STAFF RECOMMENDATION 1104 Fatherland Street October 19, 2016

Application: New construction - addition
District: Lockeland Springs-East End Neighborhood Conservation Zoning Overlay
Council District: 06
Map and Parcel Number: 08313009700
Applicant: John Root, rootARCH
Project Lead: Melissa Sajid, melissa.sajid@nashville.gov

Description of Project: Application is to construct a rear addition. No changes are proposed to the existing historic structure.

Figure 1: 1104 Fatherland Street

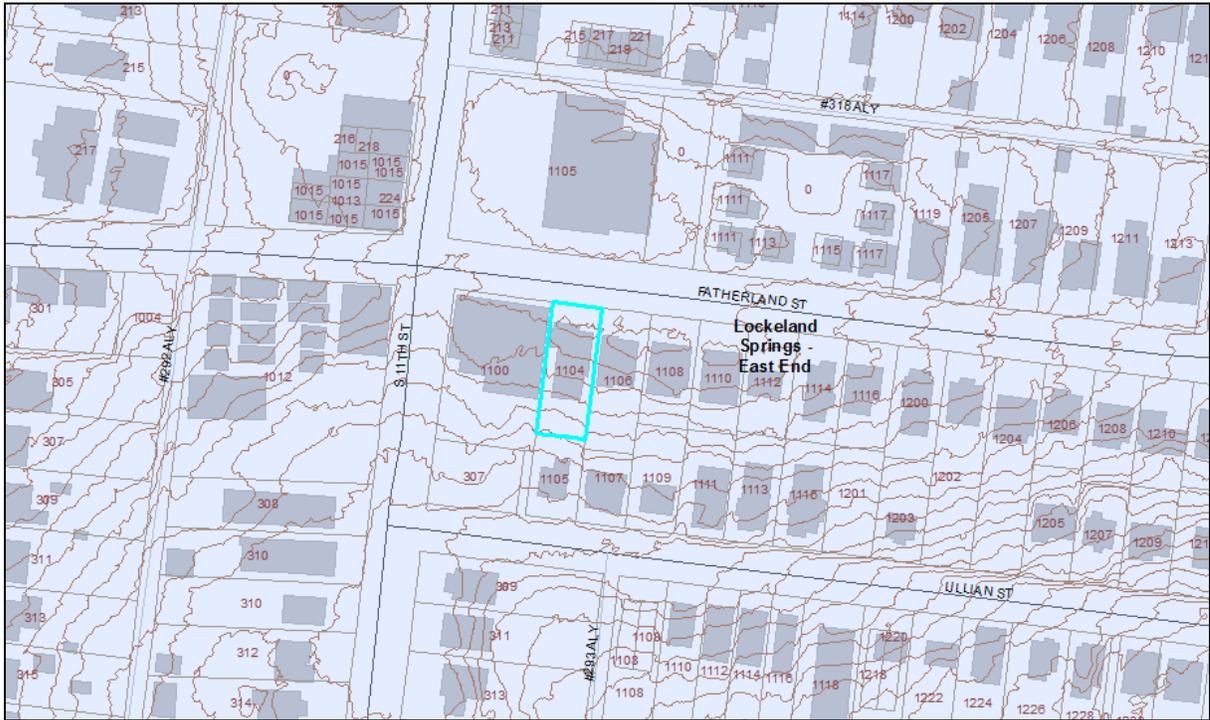
Background: The single-story building located at 1104 Fatherland Street was built c. 1914 (Figure 1). The house contributes to the historic character of the Lockeland Springs – East End Neighborhood Conservation Zoning Overlay.

Figure 2: 1914 Sanborn map

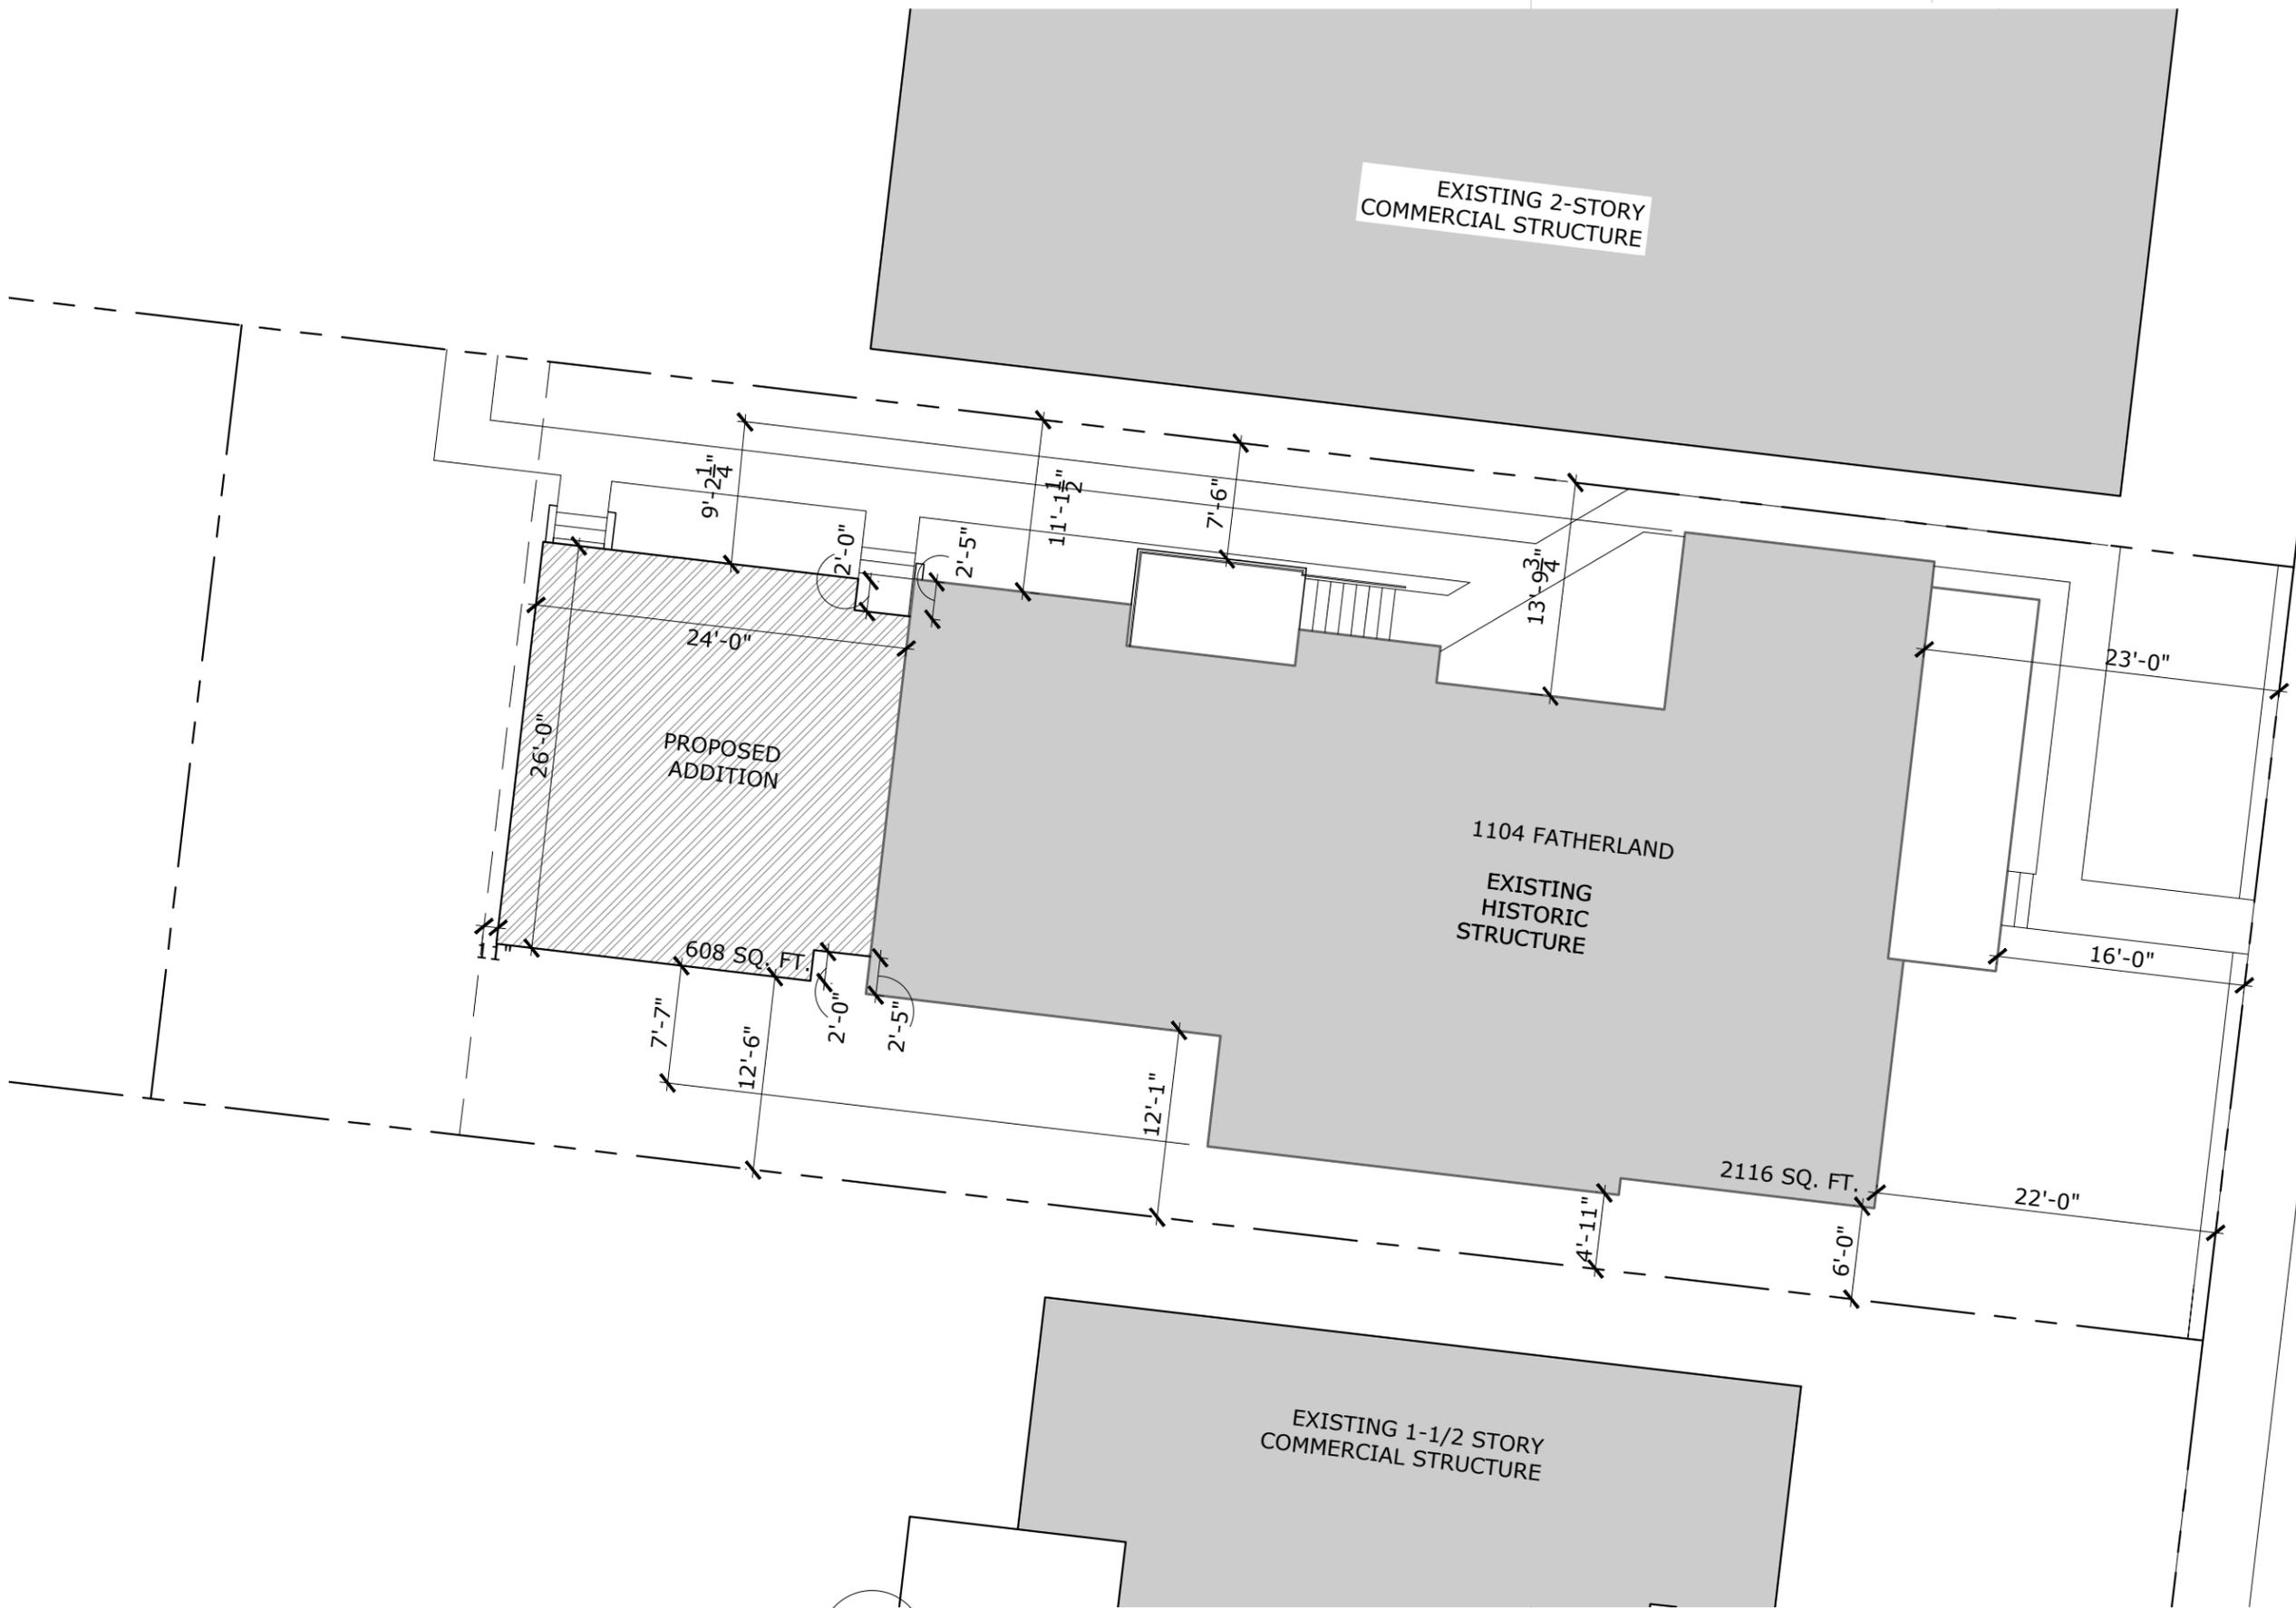
Design, Location & Removability: The new construction is located at the rear of the historic house, in accordance with design guidelines and meets the design guideline that requires the new construction to be inset one foot (1') per story from the rear corners of the historic house. As proposed, the two-story and one-half story addition sets in two feet, five inches (2'-5") from both rear corners of the historic structure. The 1914 Sanborn map, however, shows that the existing rear corners are likely original to the structure (See Figure 2). Setting in the addition one foot (1') per story helps to ensure that the new construction is distinguished from the existing historic structure, allows the full form of the original building to be kept intact and would allow for original conditions to be restored, if desired in

the future. As proposed, the addition meets this requirement. Staff finds that the project meets Sections II.B.10.a.

SOUTH ELEVATION

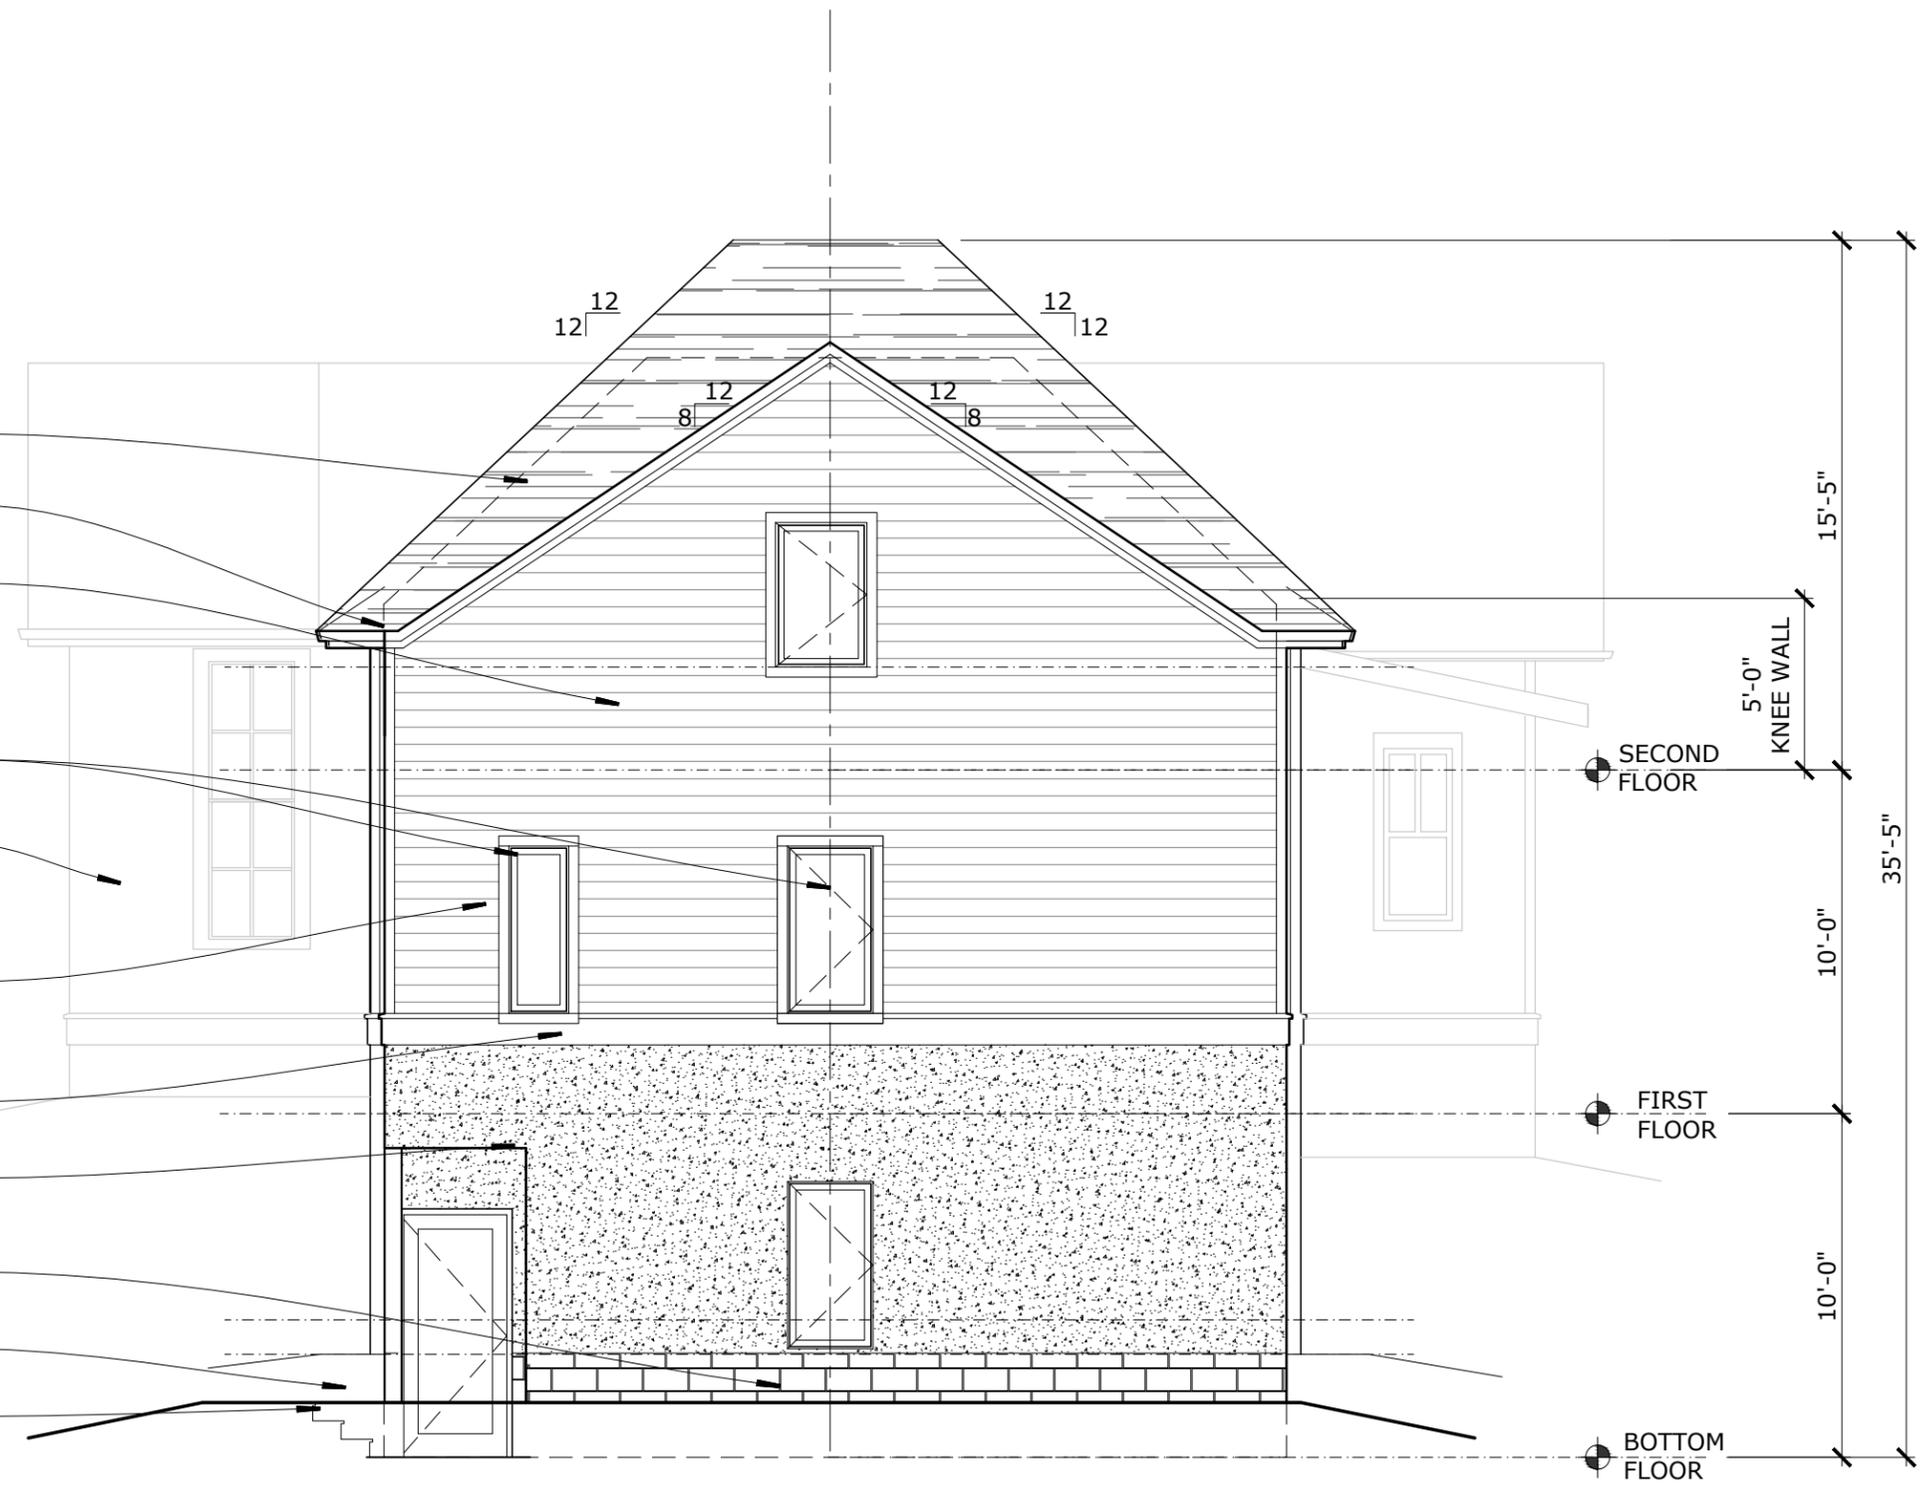
As proposed, the addition is three feet, seven inches (3'-7") taller than the historic structure, and the additional height is located approximately seventy-four feet (74') from the front wall of the historic structure. The design guidelines allow additions to be up to four feet (4') taller than a historic structure when the additional height is located at least forty feet (40') from the front edge of the existing building and only when additional height is needed. Although it does not appear that additional height is required, Staff finds that the proposed is appropriate as it is located more than forty feet (40') from the front edge of the existing building and only a small portion of roof will likely be visible from the street. The additional height does not span the entire width of the building and, in fact, is only approximately twelve to fourteen (12'-14') wide, on the portion that extends above the existing roof. The entirety of the section above the existing roof will

Roof form: The roof of the addition is cross-gabled with pitches of 8:12 and 12:12, and the taller, rear-facing gable is clipped which helps to minimize its visibility from the front of the building. The proposed roof forms and pitches complement the historic structure and are common in the neighborhood. The project meets section II.B.1.e of the design guidelines.
